RE: **Lot 16 Block 1 Volcano Cliffs Unit 22 SAD 228**  
**8011 Agua Fria Ct. NW**  
**Grading and Drainage Plan**  
**Engineers Stamp Date 10/21/2020 (D10D003N16)**  
**Pad Certification Dated: 5/10/2021**

Based upon the information provided in your submittal received 6/25/2021, this plan is approved for Building Permit.

**Re: Pulte at Volcano Cliffs Unit 18  
Erosion and Sediment Control Plan  
Engineer's Stamp Date 6/17/2021 (D10E003\_P)**

Based upon the information provided in your submittal received 6/16/2021, the above referenced plan is approved to be included in the SWPPP and Building Permit plans.

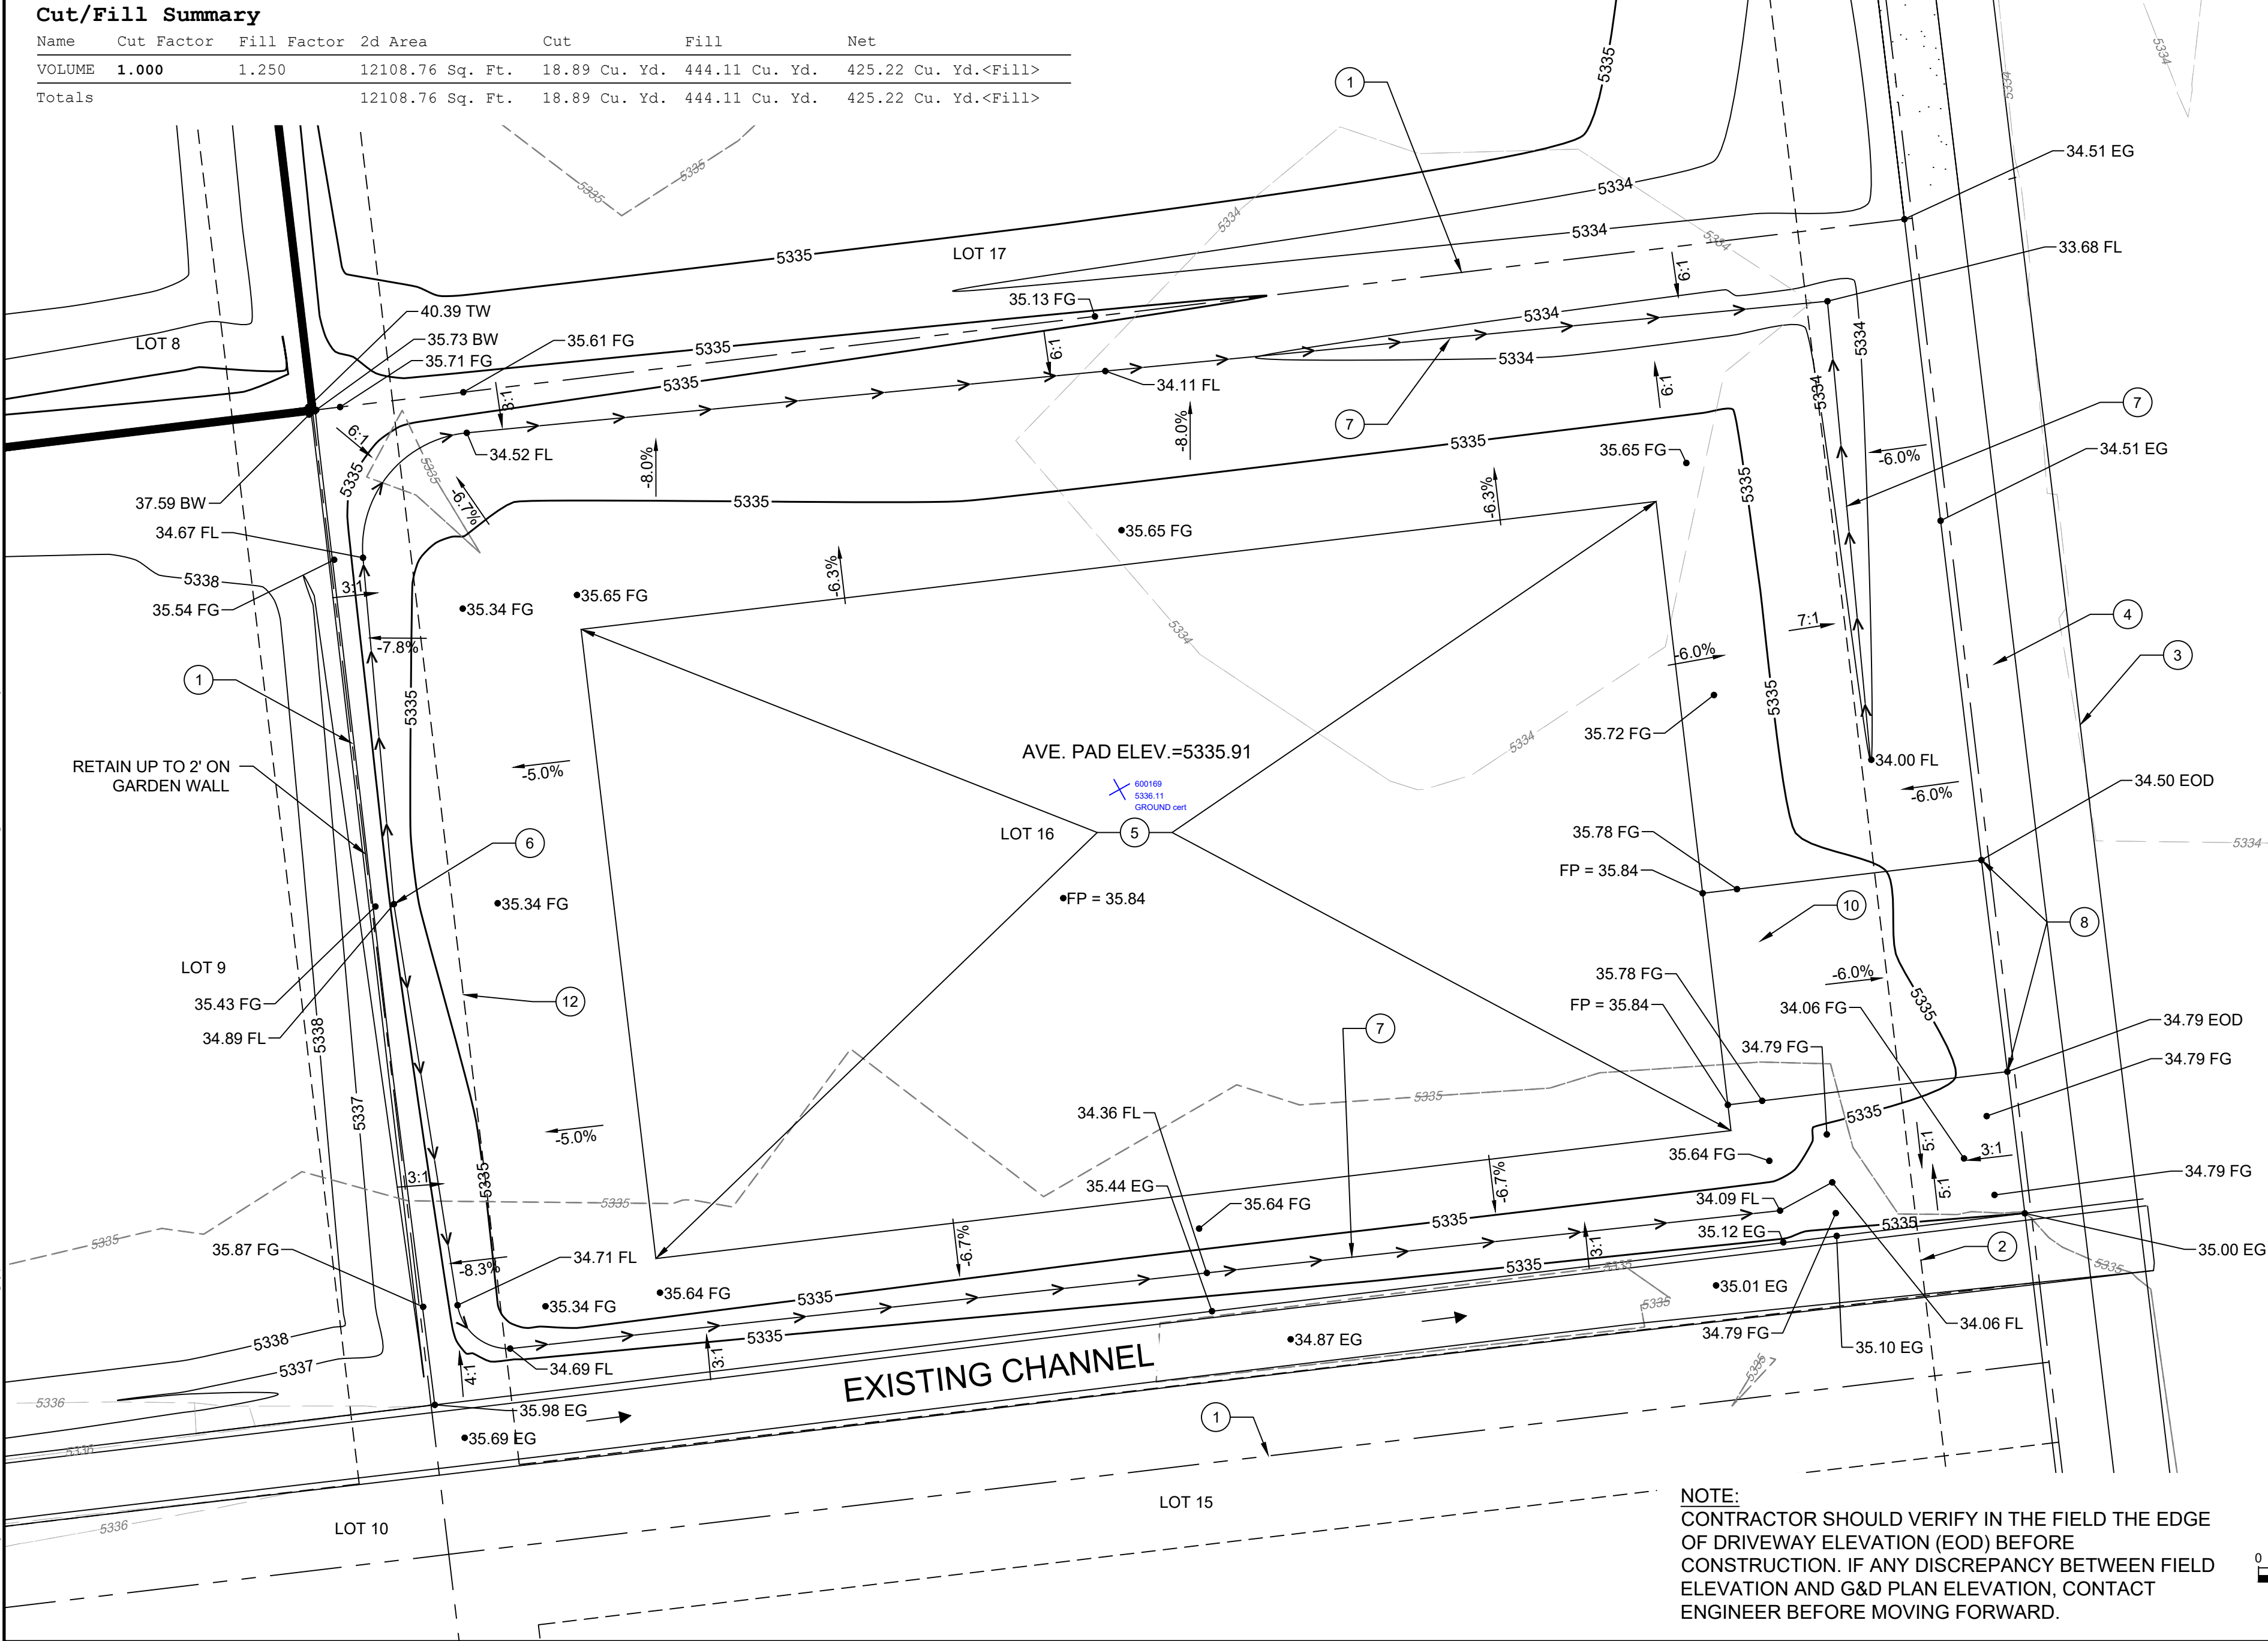
Reiterate to the Owner/Contractor that a separate permit for a garden/retaining wall must be obtained with the approved G&D plan and Pad Certification. **Also, if a swimming pool is to be placed the grading and drainage plan will change and will need to be resubmitted showing location of pool and land treatment changes.**

**Prior to Certificate of Occupancy release, Engineer Certification per the DPM checklist will be required.**
